## PRODUCT CHANGE NOTIFICATION

**Product Identification:** Bel 0863, 0864, 0873 2x4, 2x6, 2x8 ICMs

**PCN Number:** PC2190135

Old finished goods

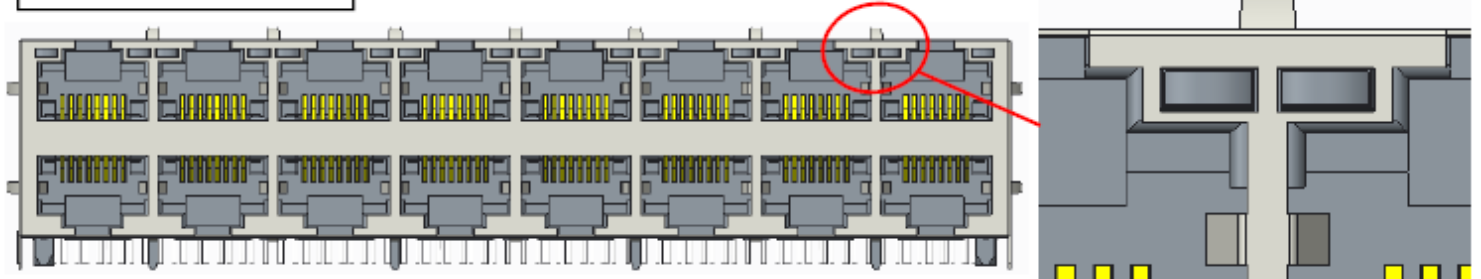
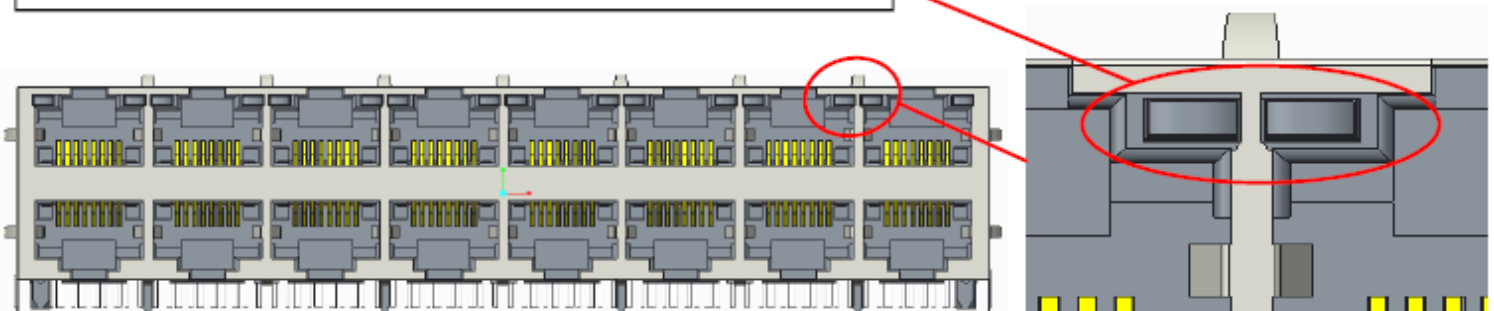
**Reason for Change (s):** In an effort to continually improve our product, Bel is pleased to announce a modification to the front shield of the 0863, 0864 and 0873 2xN ICMs in the specific area of the light-pipe and front shield. As shown below the gap between the light-pipe and shield is too small and can cause the shield to bend or become misaligned and create a snagging hazard. The solution is to remove the thin window frames from around the inside and bottom of the light-pipe.

**Description of the Change (s):** To resolve the assembly issue and deformation of the shield around the light-pipe, the thin, shield window frames around the inside and bottom of the light-pipe will be removed. By removing these thin metal pieces, the limited gap issue will be resolved and there will not be a concern for shield deformation. Please see the details below.

New finished goods: remove the LED window features.
